On behalf of Clayton Properties Group LLC, CORE Consultants, Aztec, Fox Tuttle Transportation Group, and Terracina Design, we have reviewed the comments from the Second Submission Review for the Prairie Point Golf Site Plan. The following is a response to comments:

Second Submission Review

PRAIRIE POINT GOLF COURSE
AURORA, COLORADO
SITE PLAN
COVER

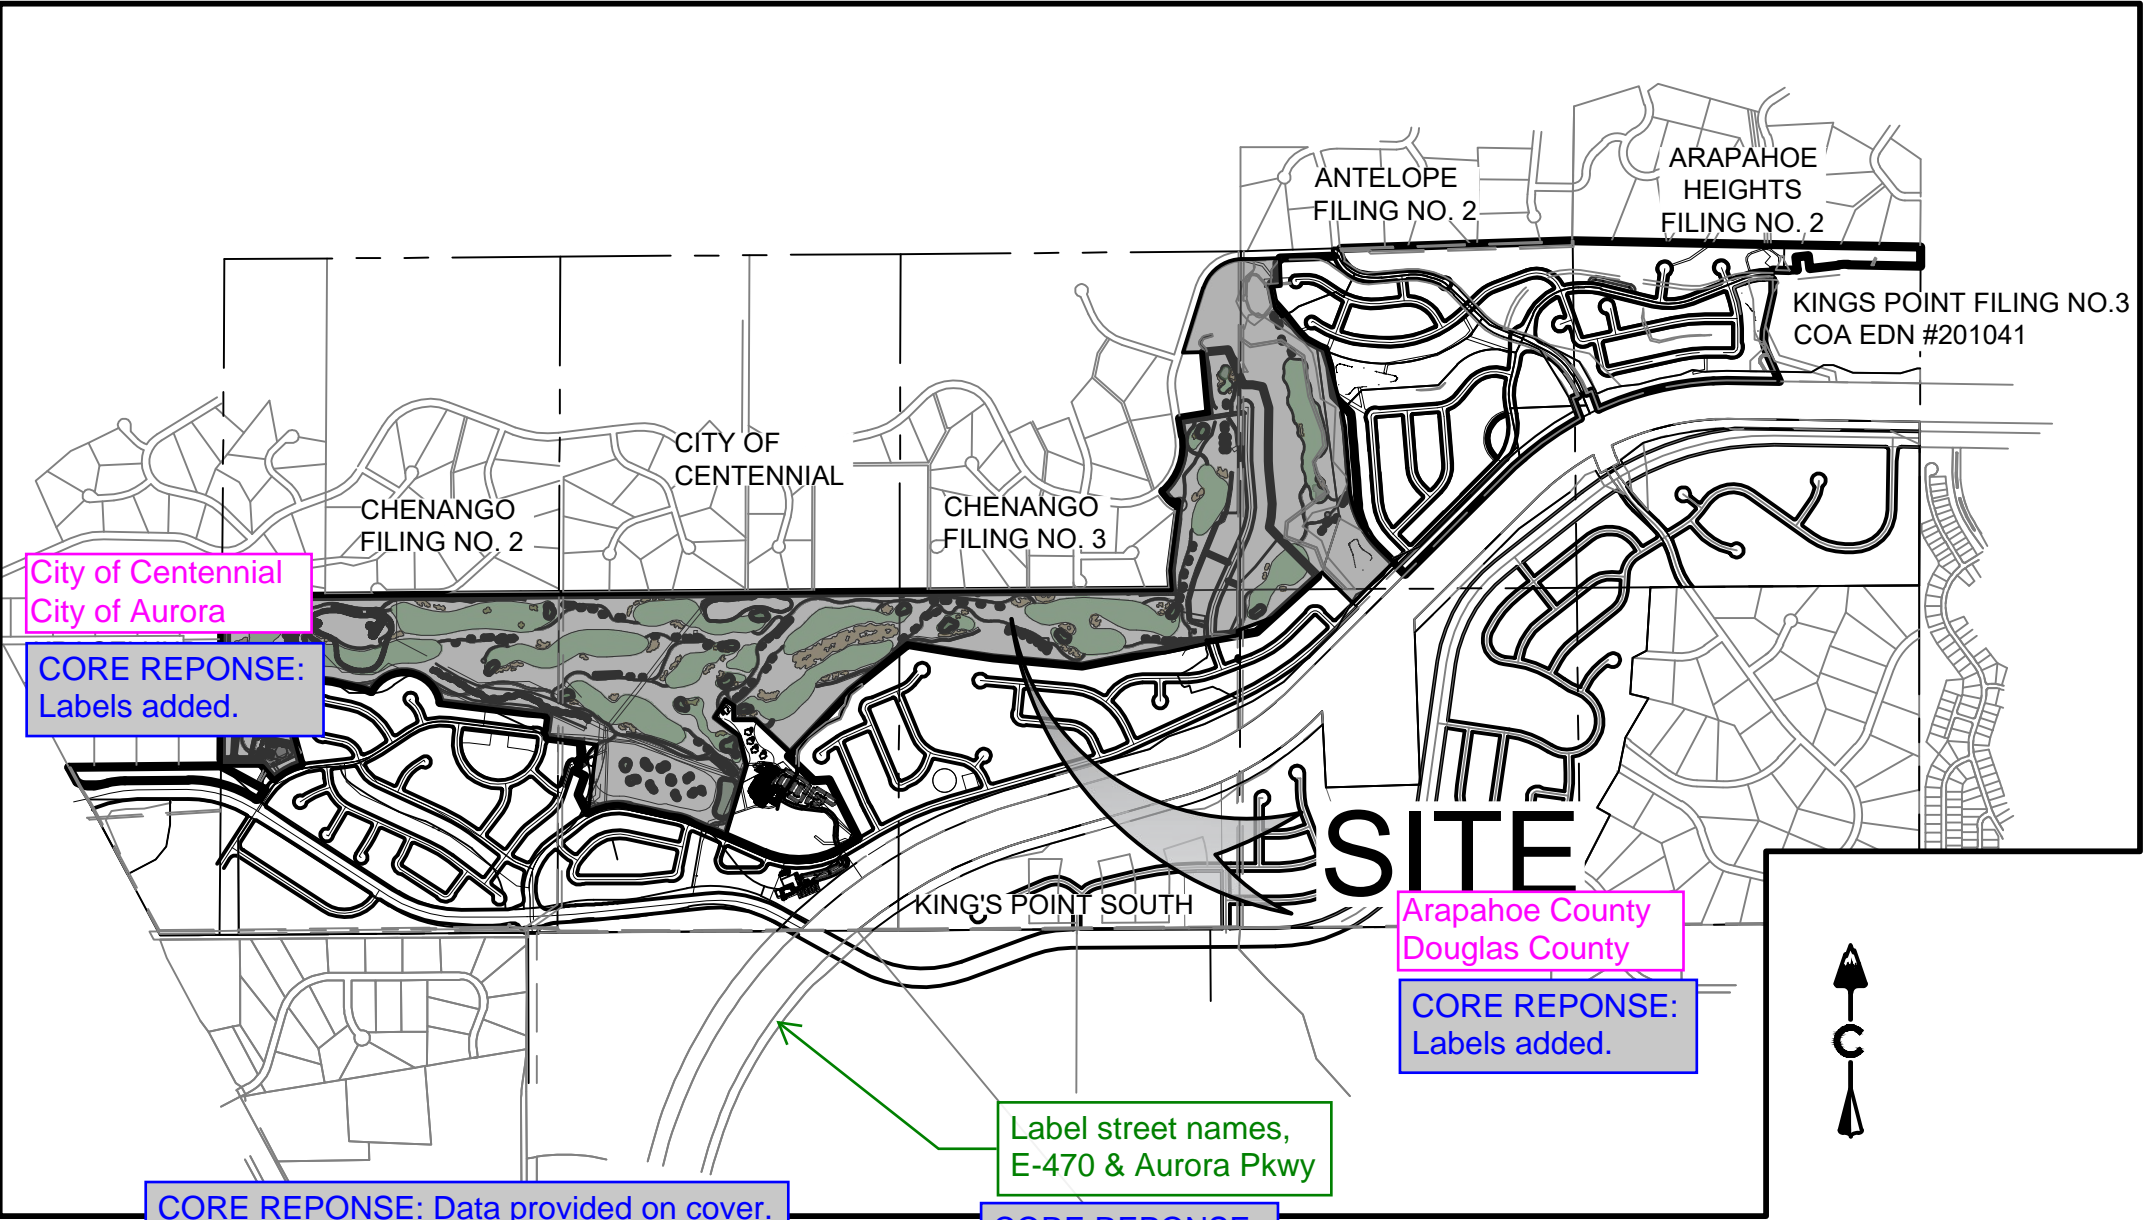
Provide the following note: A licensed contractor is required to obtain a valid building permit through the Aurora Building Division prior to the installation of any gating system utilized by emergency responders to enter the site. Call 303-739-7420 to begin the plan review, permitting and inspection processes.

The Site Plan will not be approved by Public Works until the preliminary drainage letter/report is approved

CORE REPOSE: Noted added to Overall Site Plan Notes.

CORE REPOSE: Noted. Preliminary drainage is being completed concurrently.

PRAIRIE POINT GOLF COURSE
AURORA, COLORADO
SITE PLAN
OVERALL DEVELOPMENT PLAN

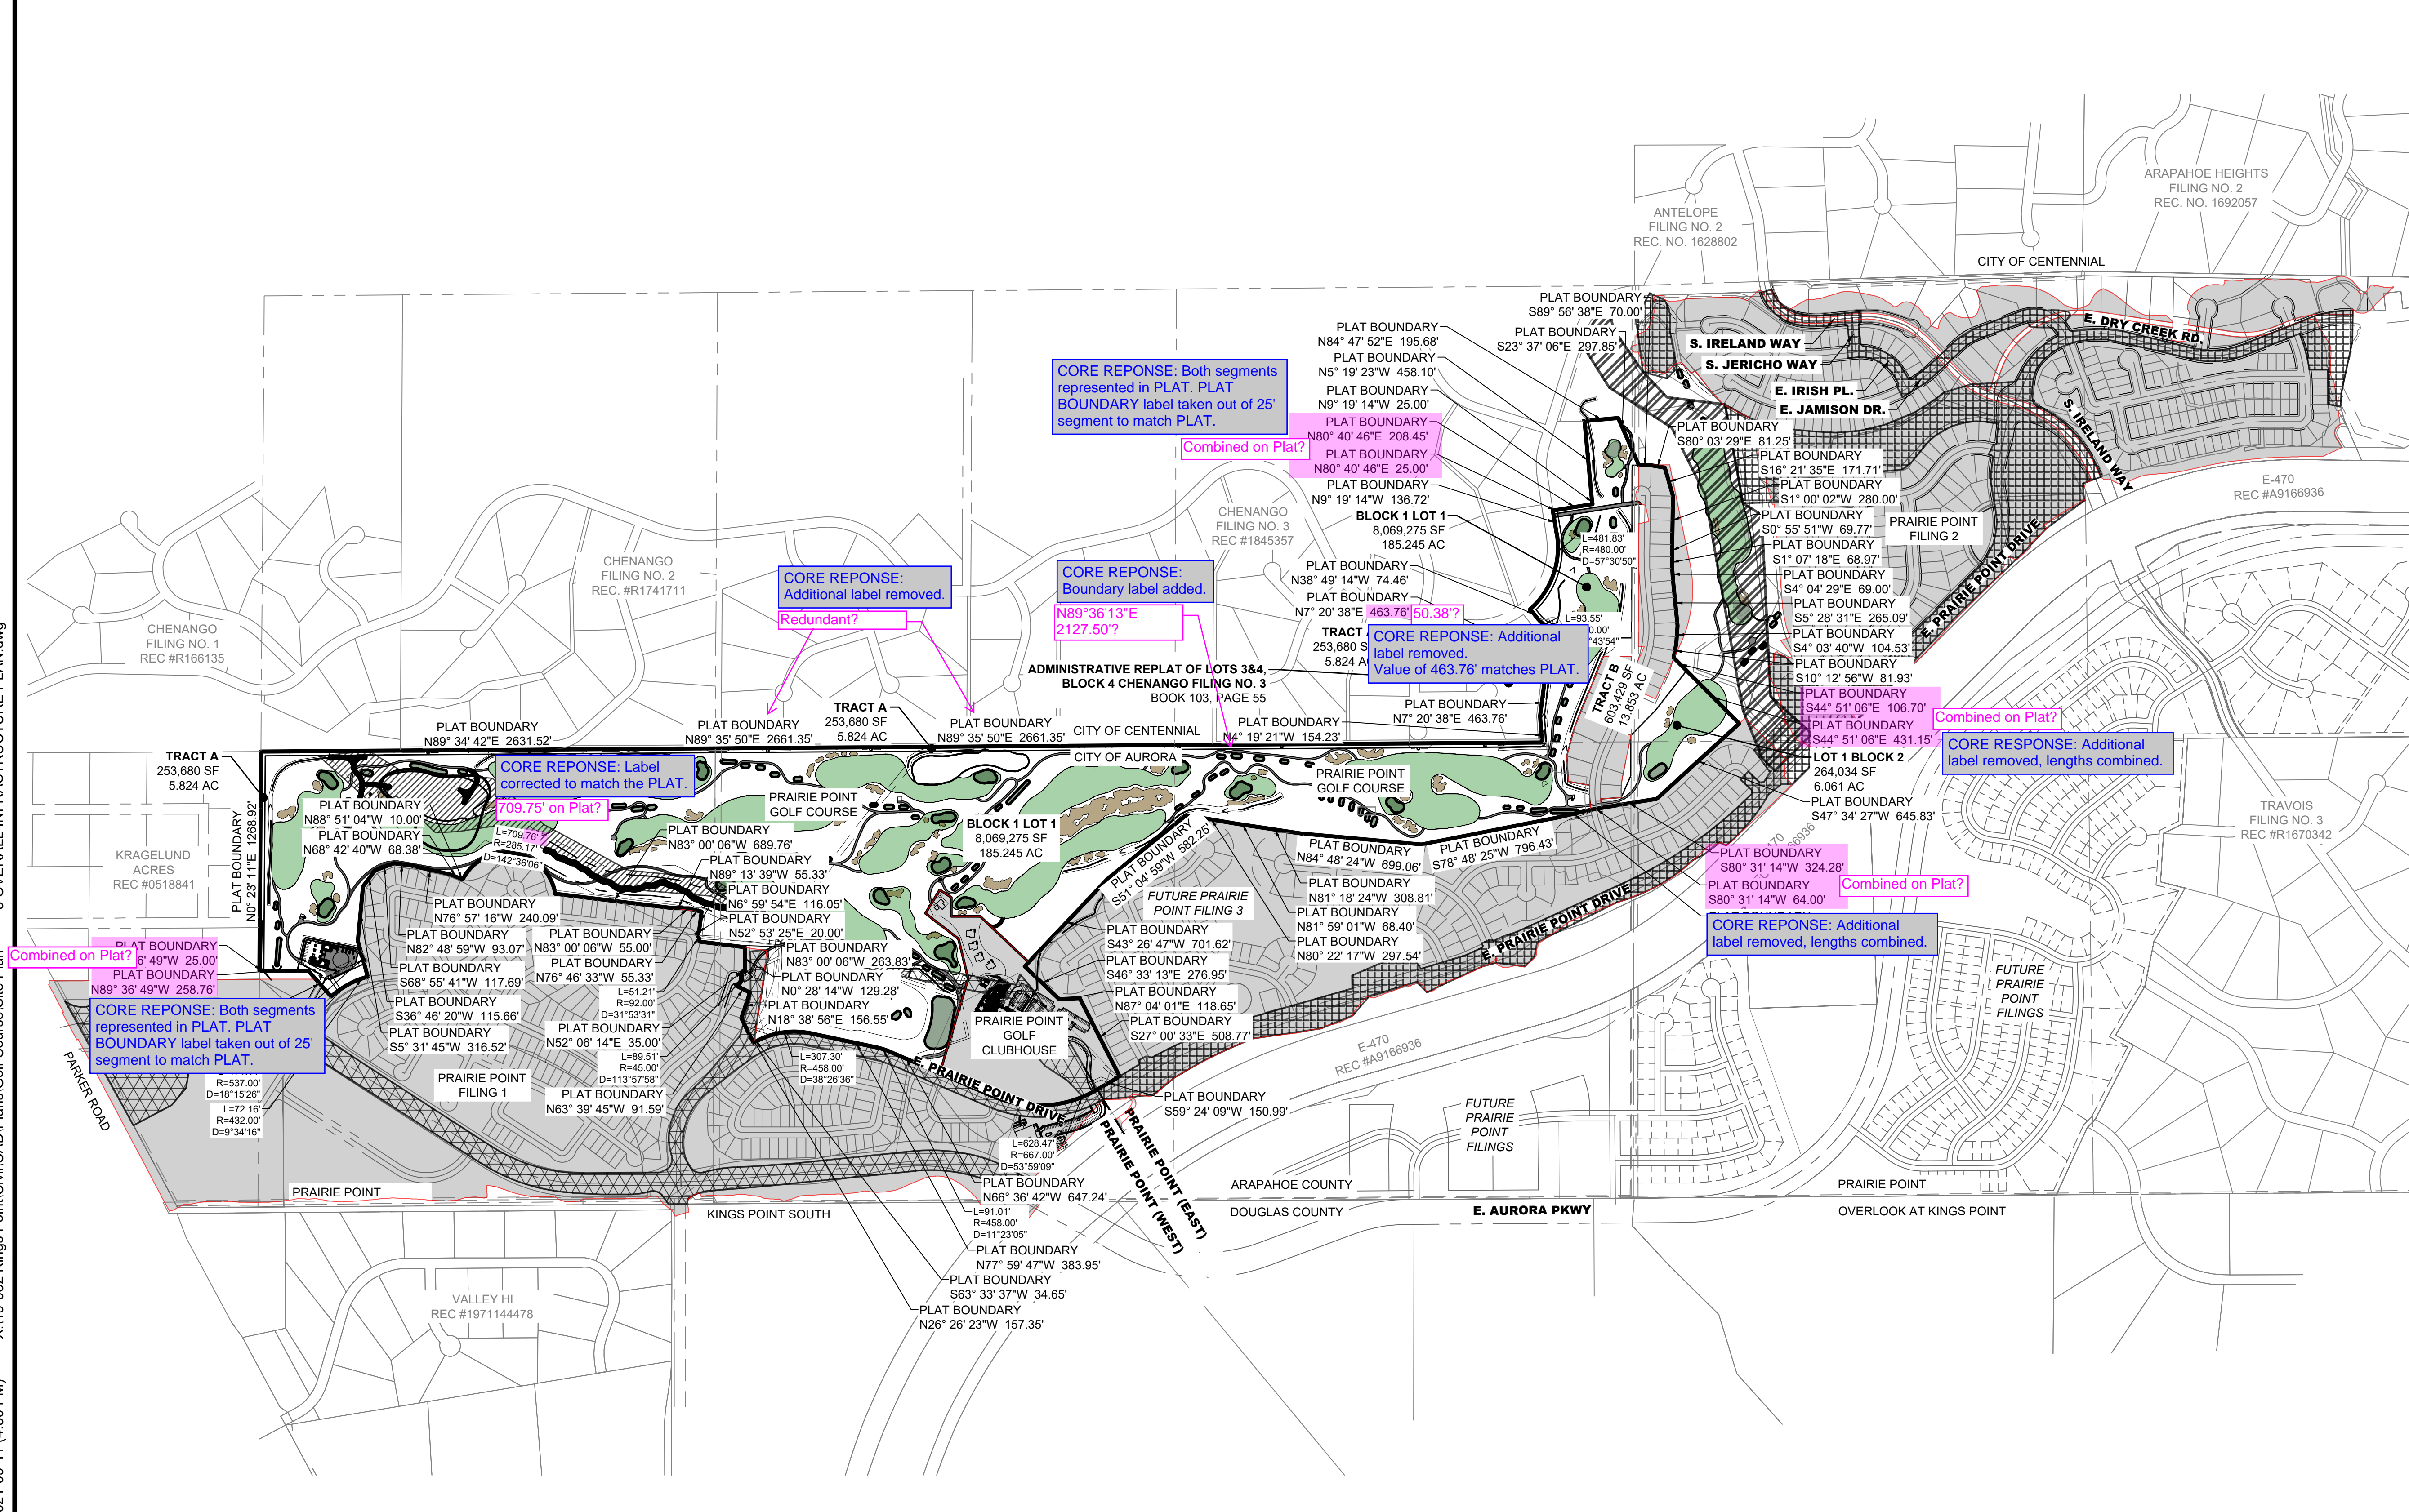
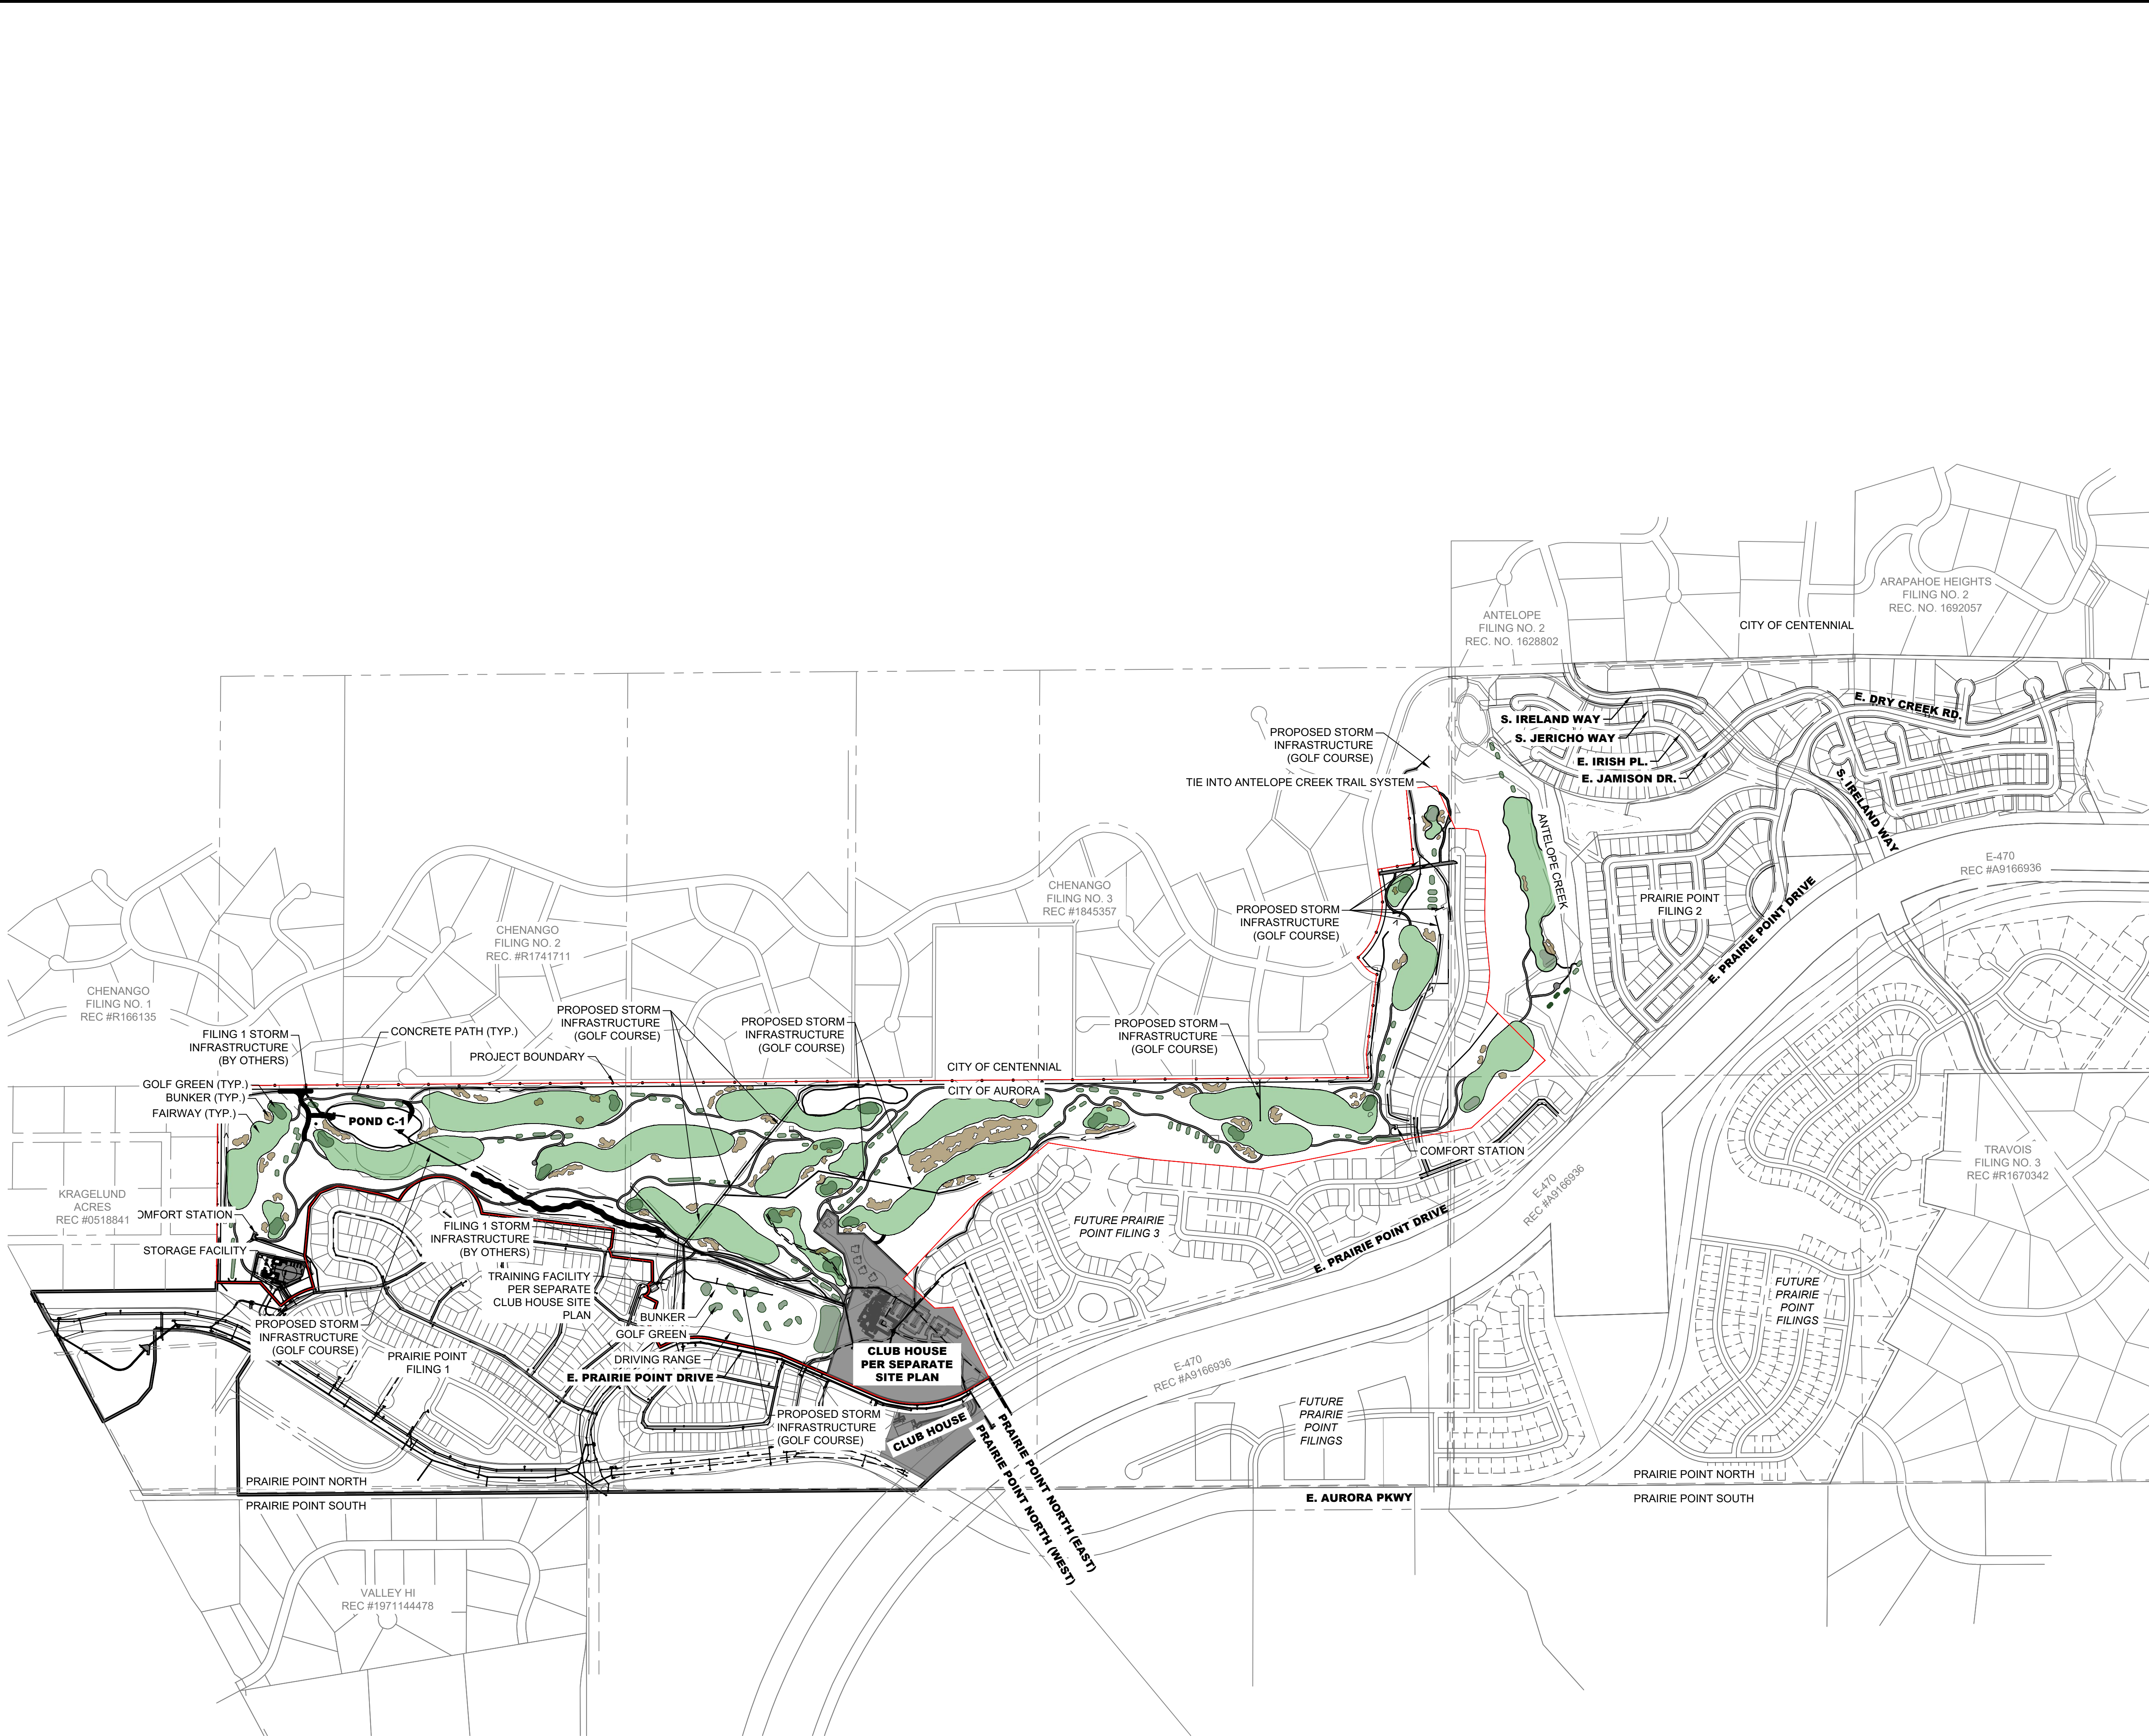
Combined on Plat?
PLAT BOUNDARY
N89° 36' 49"W 25.00'
PLAT BOUNDARY
N89° 36' 49"W 258.76'

CORE REPOSE: Both segments
represented in PLAT. PLAT
BOUNDARY label taken out of 25'
segment to match PLAT.

CORE REPOSE:
Additional label removed.
Redundant?

CORE REPOSE:
Boundary label added.
N89°36'13"E
2127.50'?

CORE REPOSE: Label
corrected to match the PLAT.
709.75' on Plat?
